# Product Change Notification (PCN)

PCN Number	505894	Date Issued	July 27, 2018
Reason for Change	Packaging Method/Quantity Changing		
Change Type Description	This letter is to inform you that the part(s) referenced in this notice will undergo packaging specification changes that may include new container sizes, quantities or changes to the label. No changes will be made to the product as a result of this change.		
Assessment of Change	Drop test approved		
Internal Molex Qualification Date	July 18, 2018		
Sample Availability Date (Changed Part)	July 18, 2018		
Planned Implementation Date	January 14, 2019

### Mini-Lock 2.5 51164\*\*05 TPA PK Change

## After Change

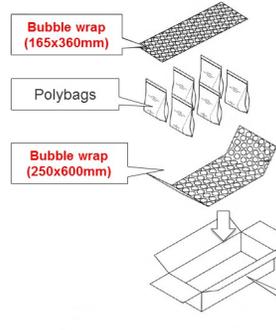
Change the packing type in the primary carton from small boxes to the bubble wraps.  
 By eliminating the 2) small boxes inside the 3) primary carton, we are expecting production (packaging) efficiency improvement as well as reduced packaging material waste at the customer.
